Subject: City of Vancouver Comments on the Draft EIS for I-5 Columbia River Crossing

City of Vancouver				
Comments on Columbia River Crossing DRAFT EIS				
CHAPTER	PAGE	SECTION	LINE	COMMENT
SUMMARY				
	S-14	Alternative 4	Figure: Supplemental Crossing with BRT	Shows primary bike/ped pathway on only one side. There is a pathway on the other side too and PBAC recommended widening both sides if this option is chosen.
	S-16	Alternative 5	Figure: Supplemental Crossing with LRT	Shows primary bike/ped pathway on only one side. There is a pathway on the other side too and PBAC recommended widening both sides if this option is chosen.
	S-19	Multimodal River Crossing & Highway Improvements	Exhibit 16	Should show bike/ped pathway on Southbound downstream side of bridge not northbound structure.
	S-21	Multimodal River Crossing & Highway Improvements	Exhibit 18	Shows primary bike/ped pathway on only one side. There is a pathway on the other side too and PBAC recommended widening both sides if this option is chosen.

Figure III-4: Project 3, Discovery Loop / Central City

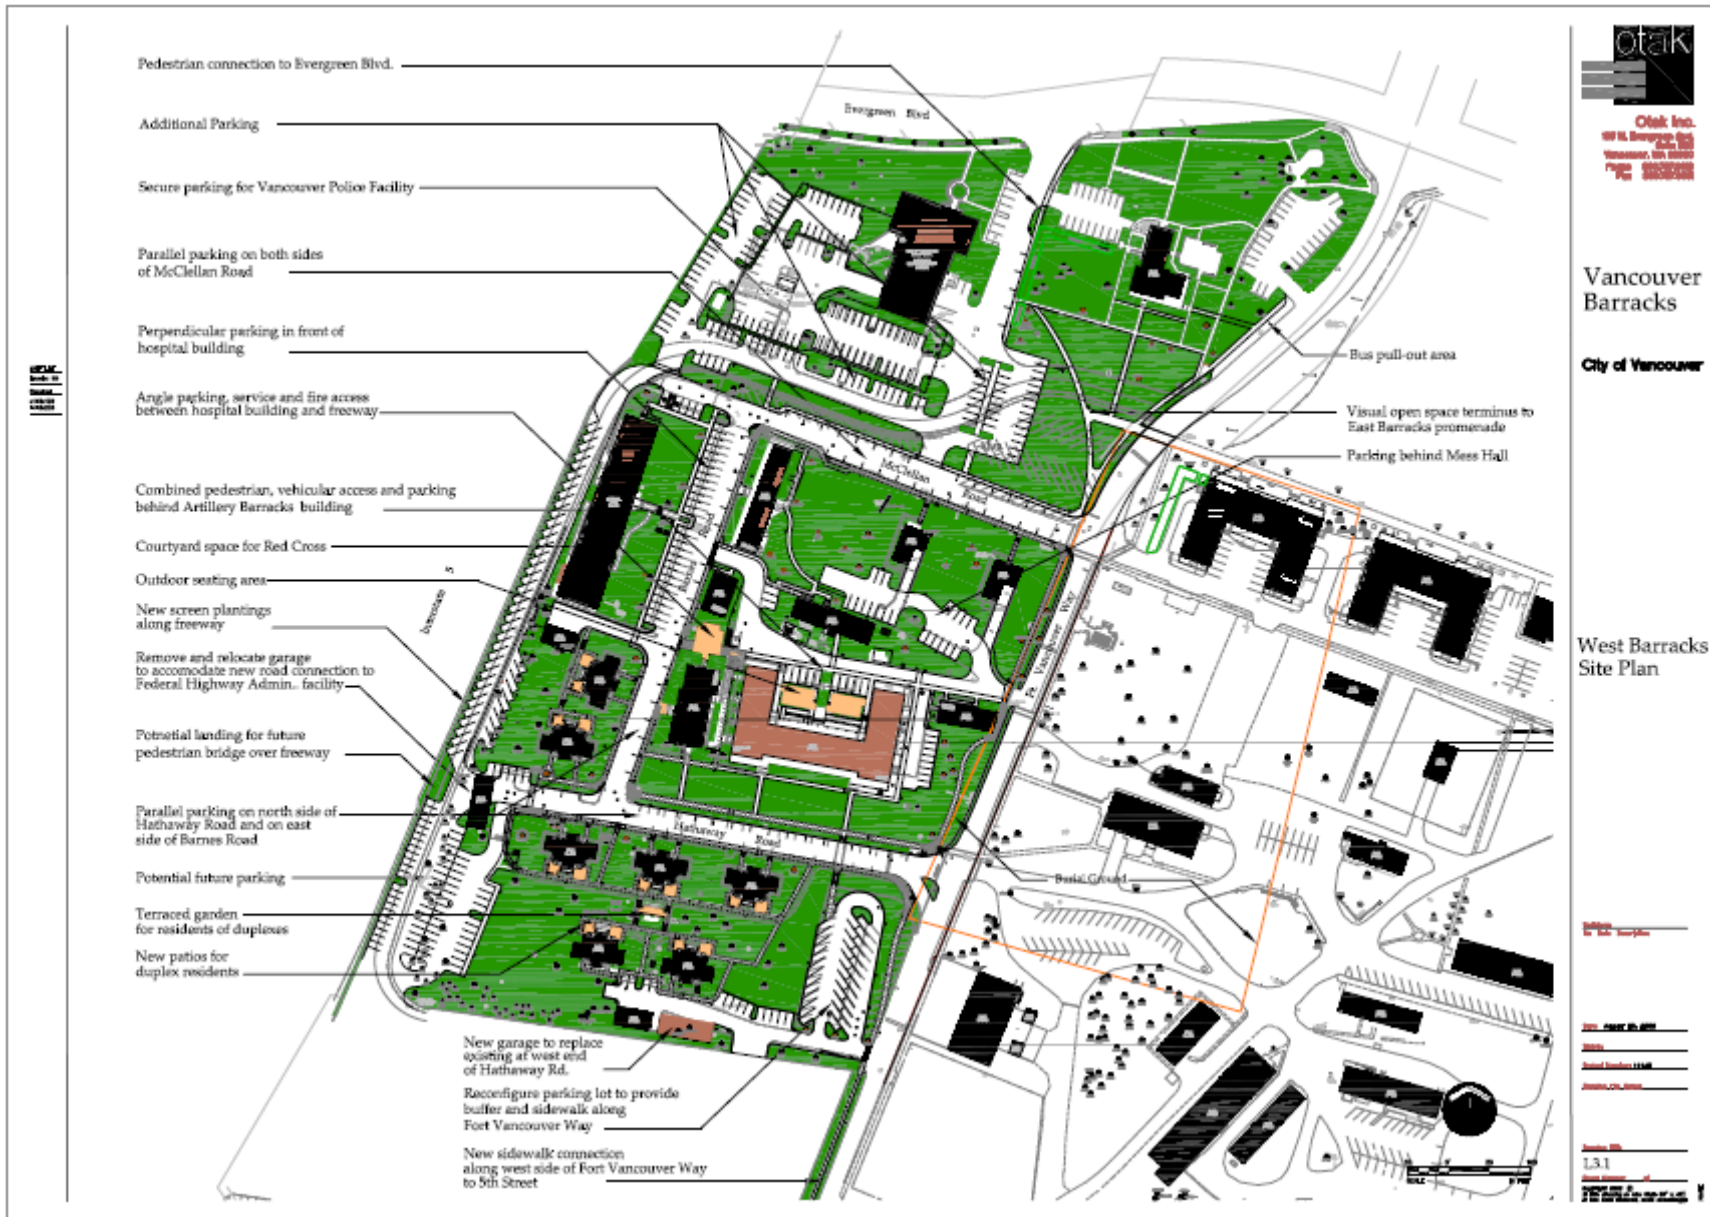
5-19	5.3.1	Exhibit 5.3-1	Impacts to the Discovery Loop Trail are not included. (See attached section of the 2004 VCPRD Paths & Trails Master Plan describing the trail and planned improvements. In addition, see information on the VCPRD website: http://www.cityofvancouver.us/parks-recreation/parks_trails/trails/discovery_loop.htm .)
	5-19	5.3.1	Exhibit 5.3-1	Vibration and visual impacts to the Post Hospital are not described, but could be significant.
	5-47			The DEIS does not include an analysis of the project's impacts to the Discovery Loop Trail which crosses I-5 on Evergreen Blvd and Columbia/Columbia Way. The impact analysis should include the disruption caused by construction and noise, air quality and aesthetic impacts to the trail user during construction and when complete.
	5-48	5.3.3	Waterfront Park	Any encroachment on the Waterfront Park, the Waterfront Renaissance Trail, and the Boat of Discovery Monument, whether in the air, or with a
